**Additions and Renovations
Platt Technical High School
Milford, CT**

ADDENDUM NO. 1

July 23, 2019

9 PROPANE TANK
NTS

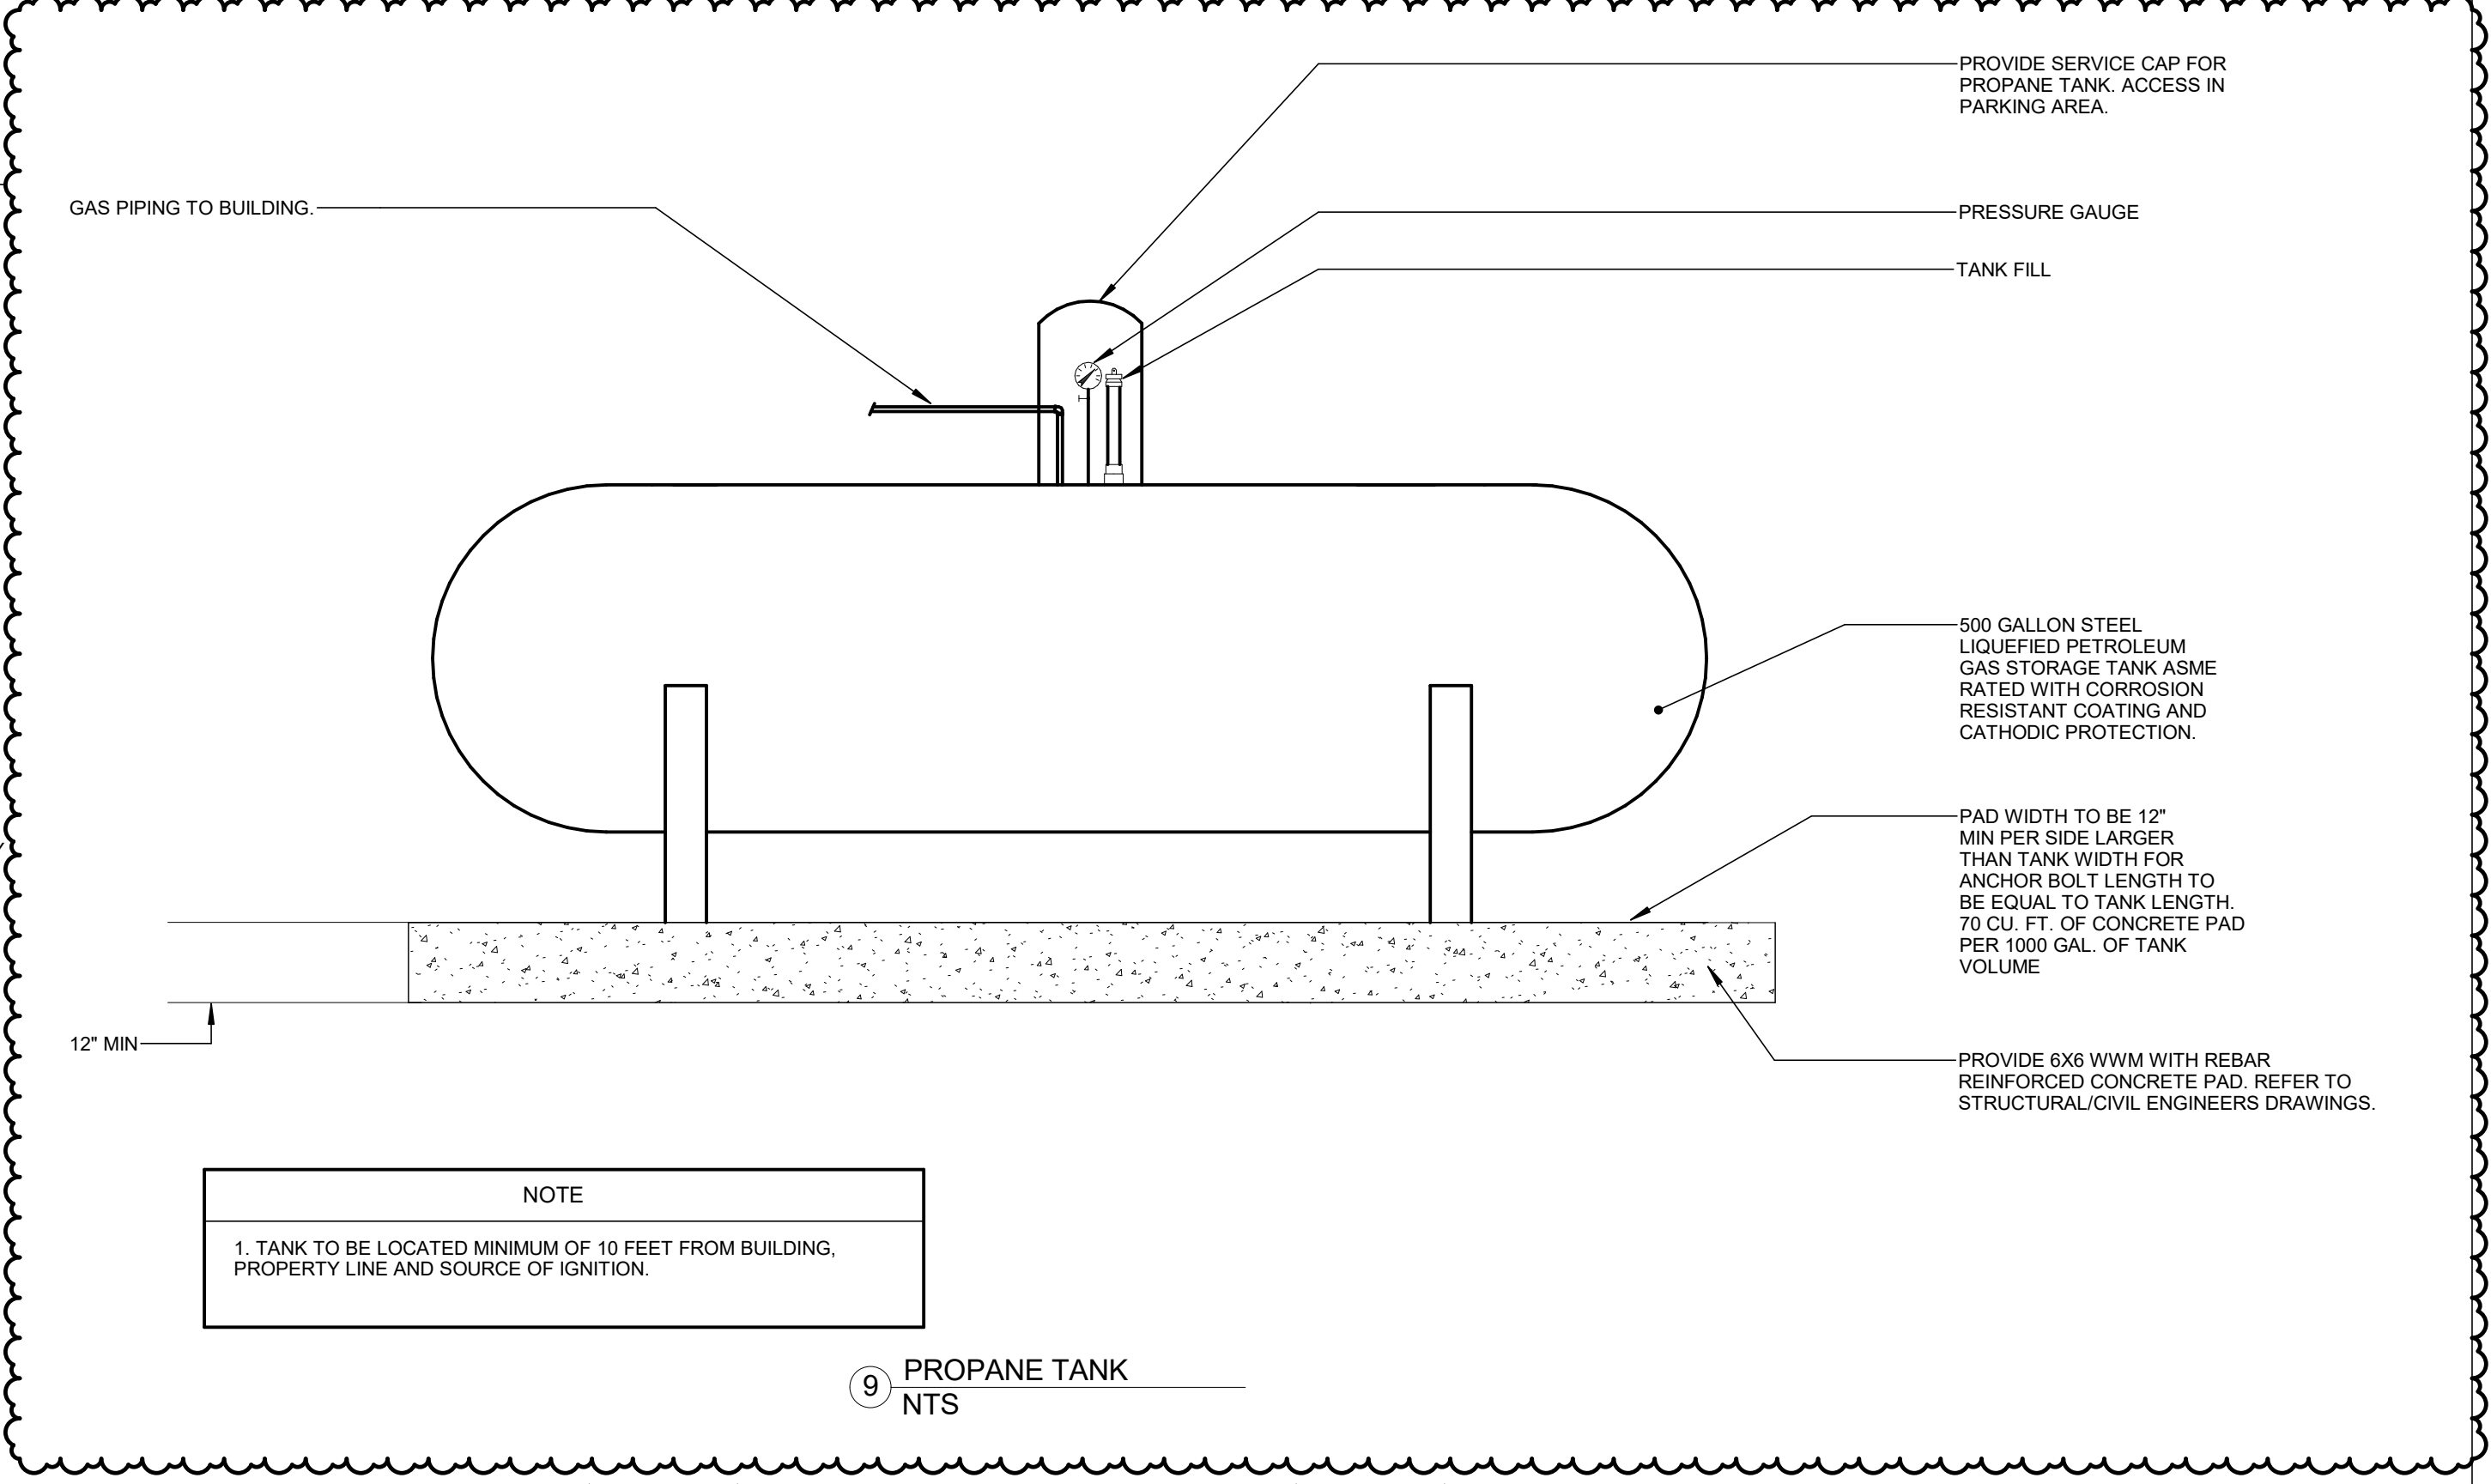
ADD 1-032 DRAWING P4-1-1 –PLUMBING DETAILS
Revised detail #9 to above ground tank, RP1-7.

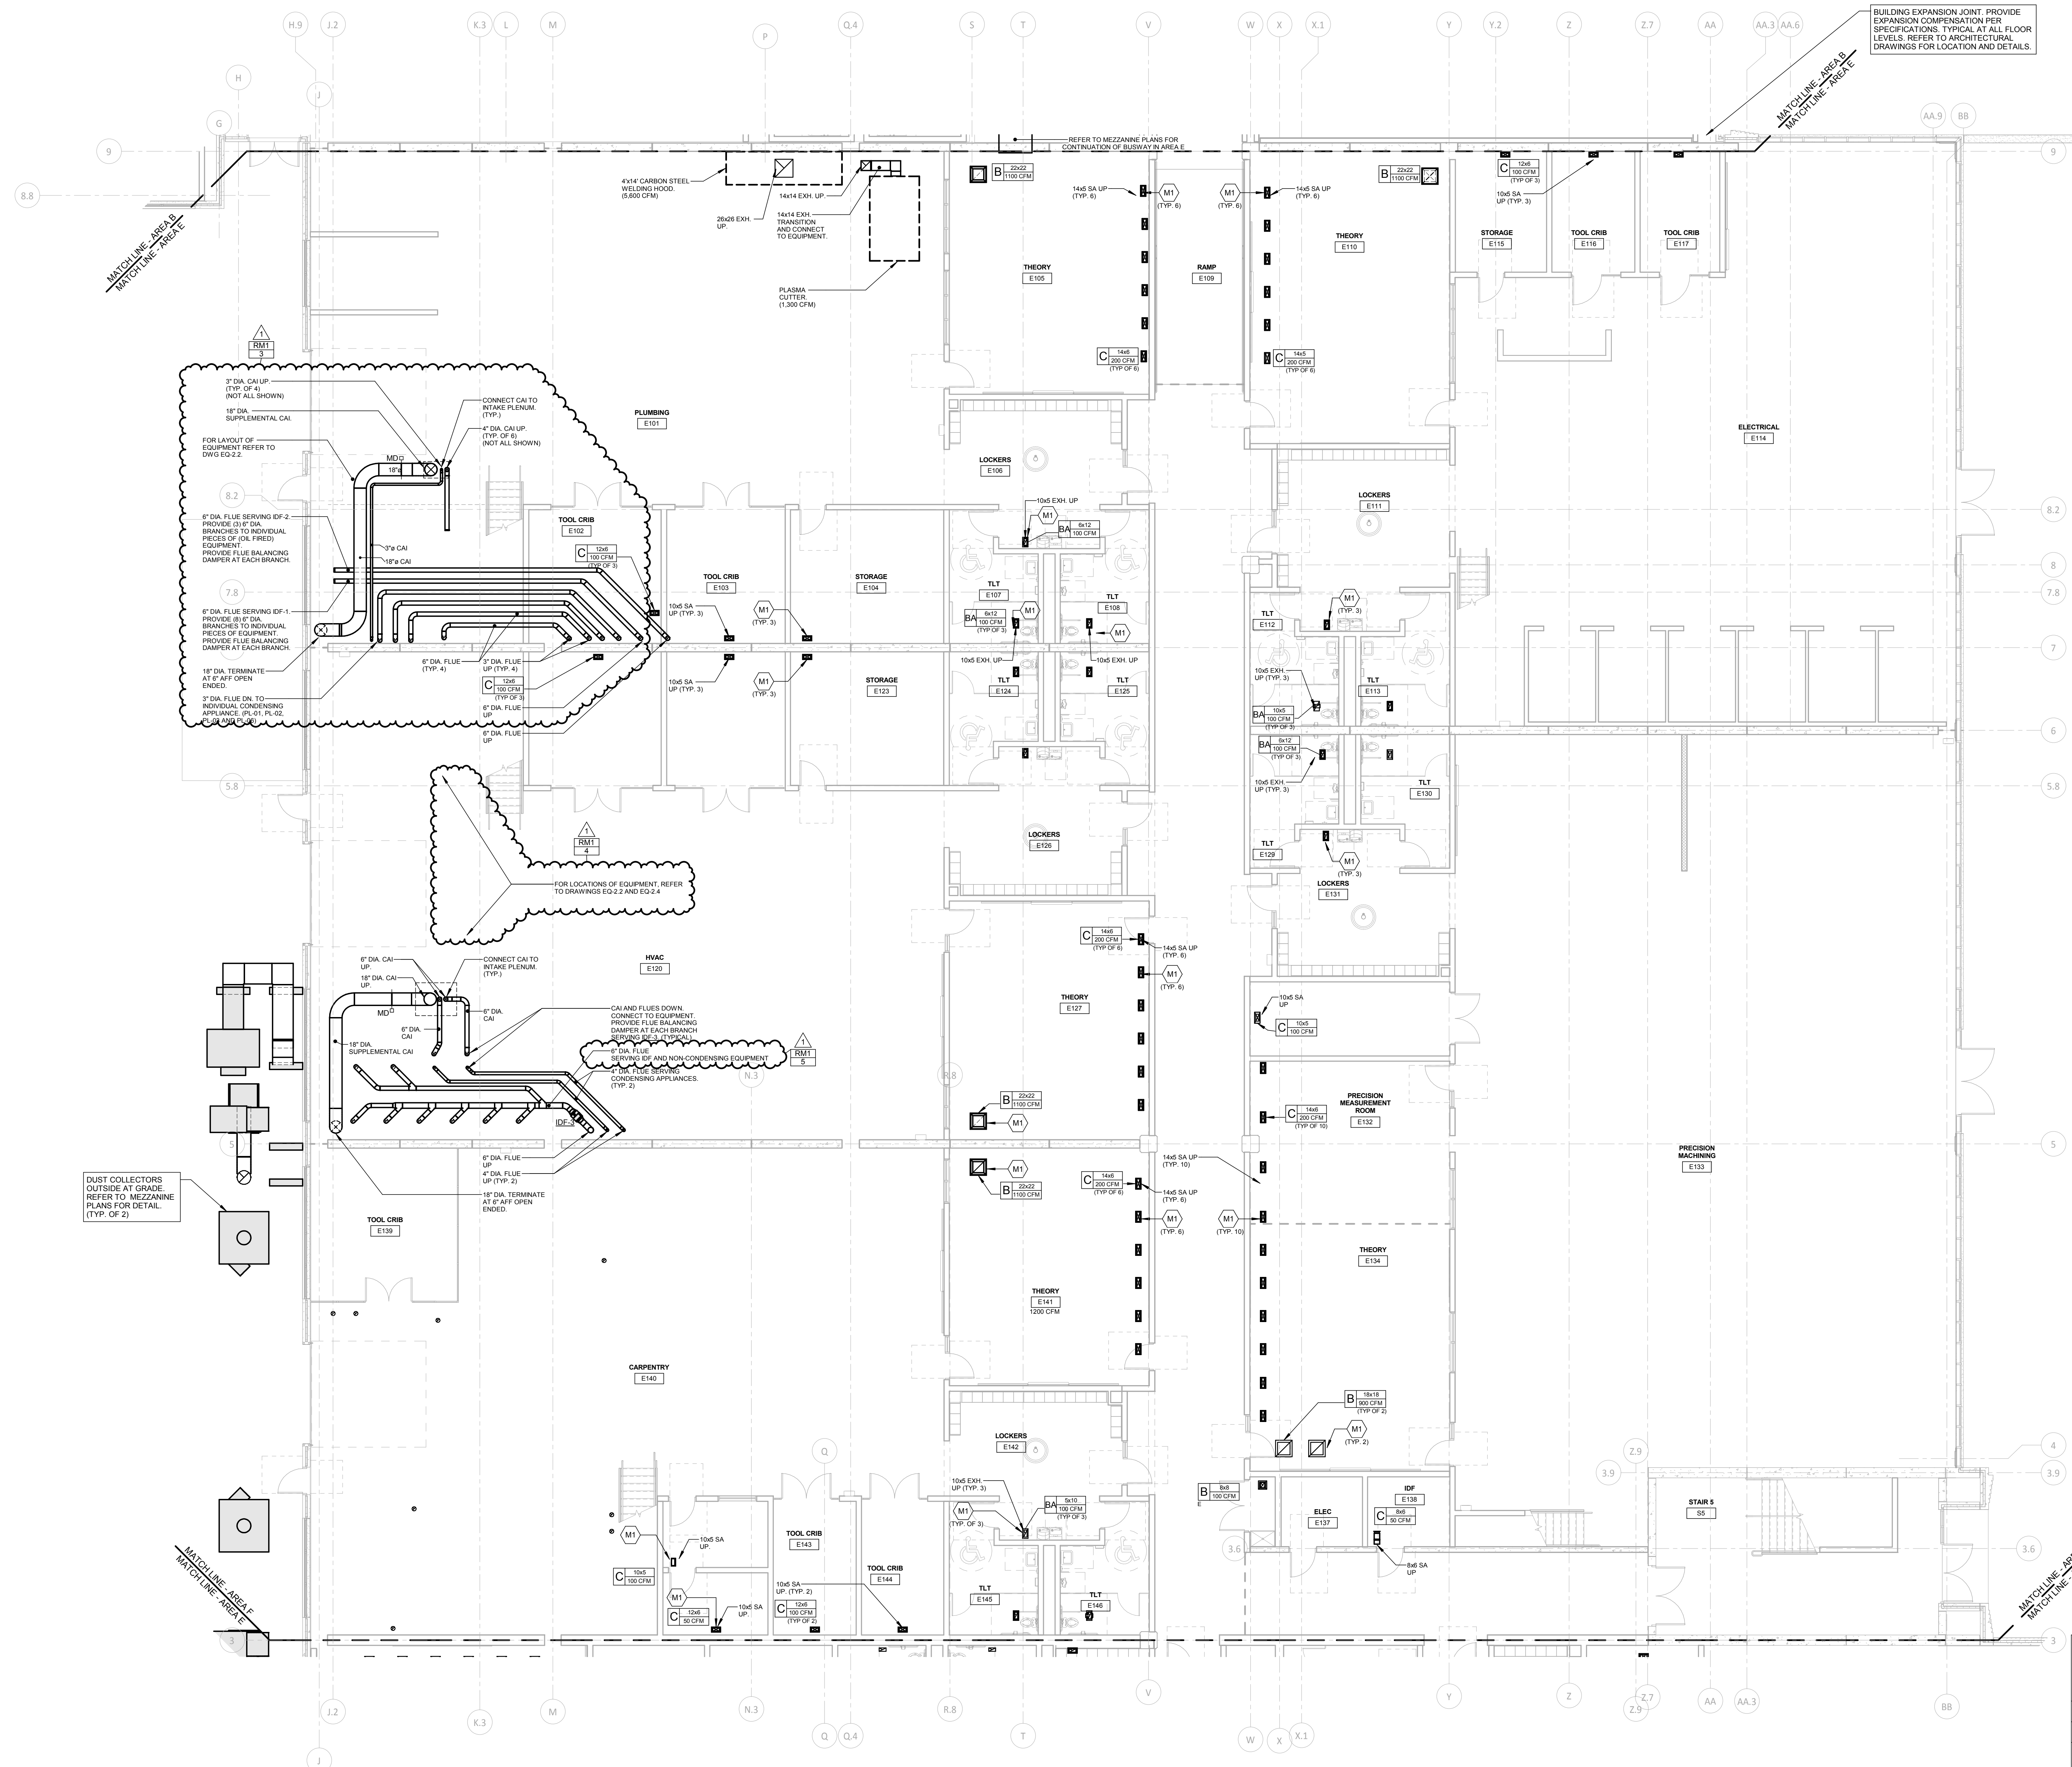
ADD 1-034 DRAWING M1-1-1A – FIRST FLOOR MECHANICAL PLAN – AREA A
Revise louver size and plenum per Revision RM1-1.
Revise louver size and plenum per Revision RM1-2.

17 DC-1 & DC-2 SPARK DETECTION/EXTINGUISHING CONTROL DIAGRAM
N.T.S.

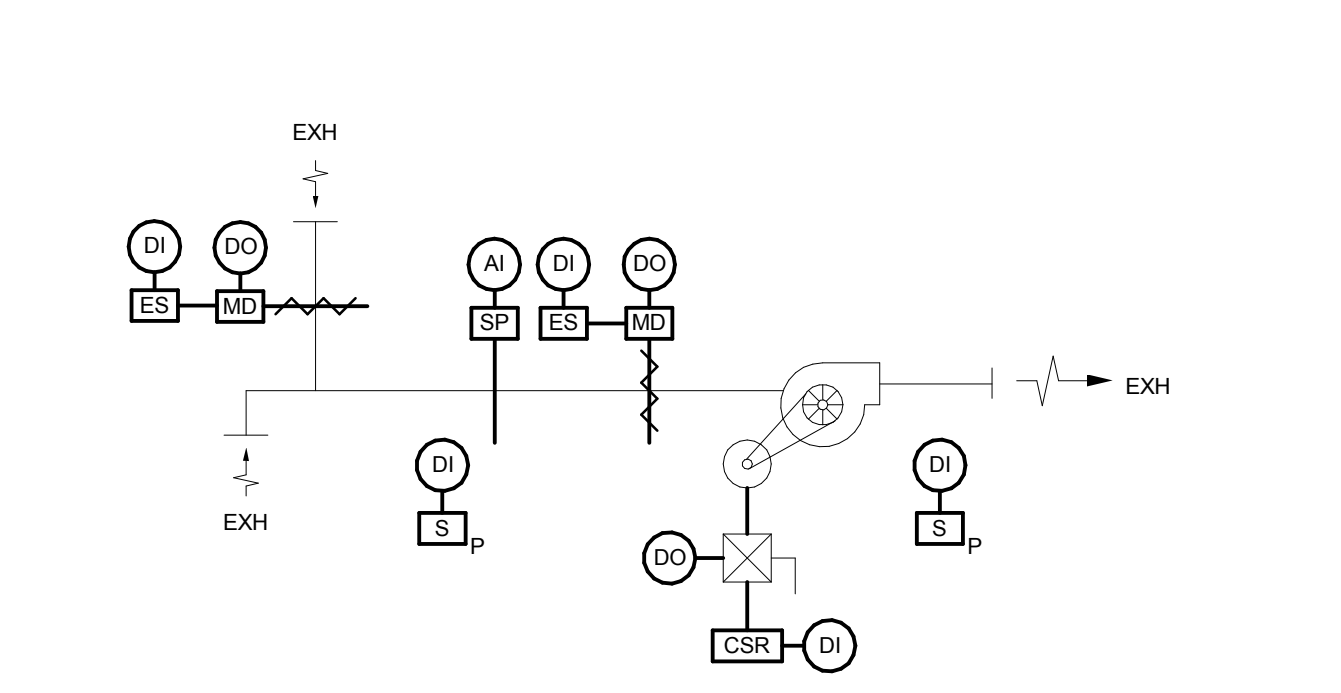
- ADD 1-044 DRAWING M3-1-3 –MECHANICAL SCHEDULES**
Update data at Induced Draft Fan Schedule per Revision RM1-20.
- ADD 1-045 DRAWING M5-1-4 –MECHANICAL CONTROLS**
Revise Detail #17 per Revision RM1-21.

4 ELEVATOR MACHINE SPACE DETAIL N.T.S.

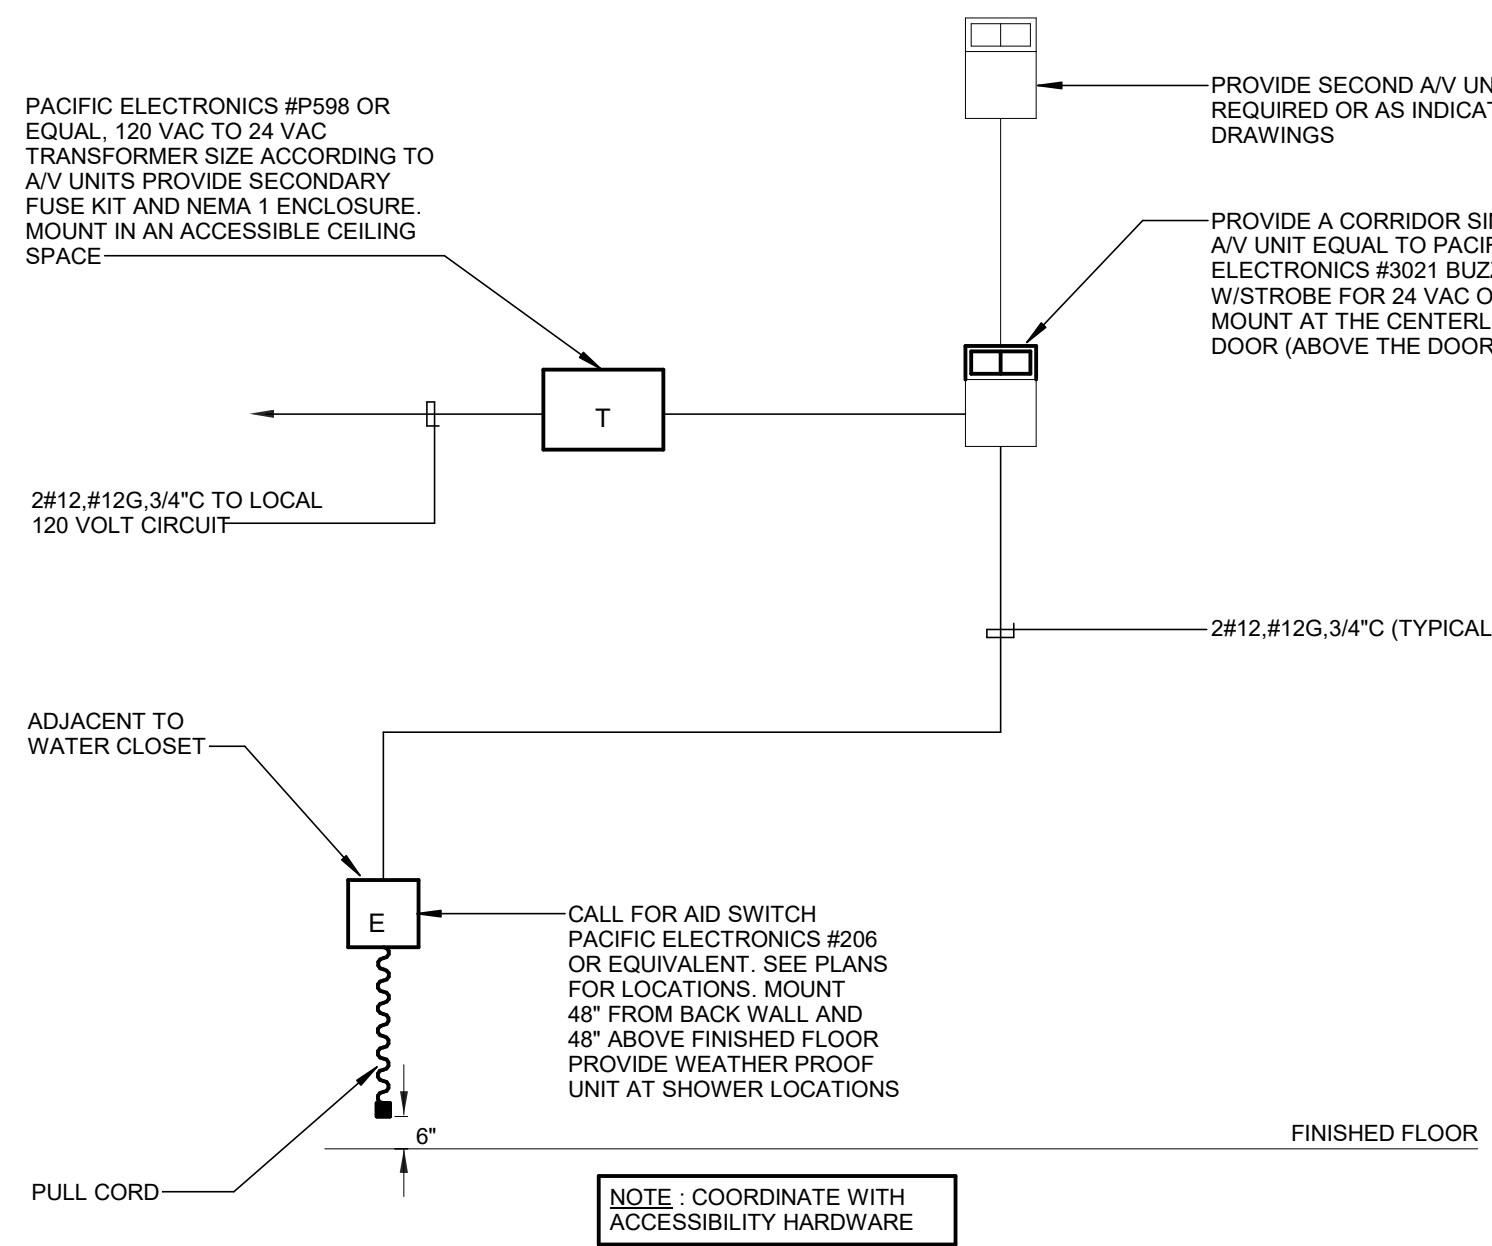
- ADD 1-049 DRAWING 6-1-1– ELECTRICAL DETAILS**
Revised elevator machine space detail for new circuit homerun per Revision RE1-5.
- ADD 1-050 DRAWING 7-1-2 – ELECTRICAL RISER DIAGRAM**
Revised 1000A circuit breaker feeding T-LDSB-1 to have GFCI protection per Revision RE1-6.
Revised PP2-2 to be a 3-section panel with 250A main circuit breaker. T-PP2-2 was upsized to a T6 transformer and the feeder and disconnect have been upsized as well as the breaker feeding the disconnect from DSB-1 per Revision RE1-7.
Moved note for elevator conduit from MEP3-2 to EPDP-2 per Revision RE1-8.
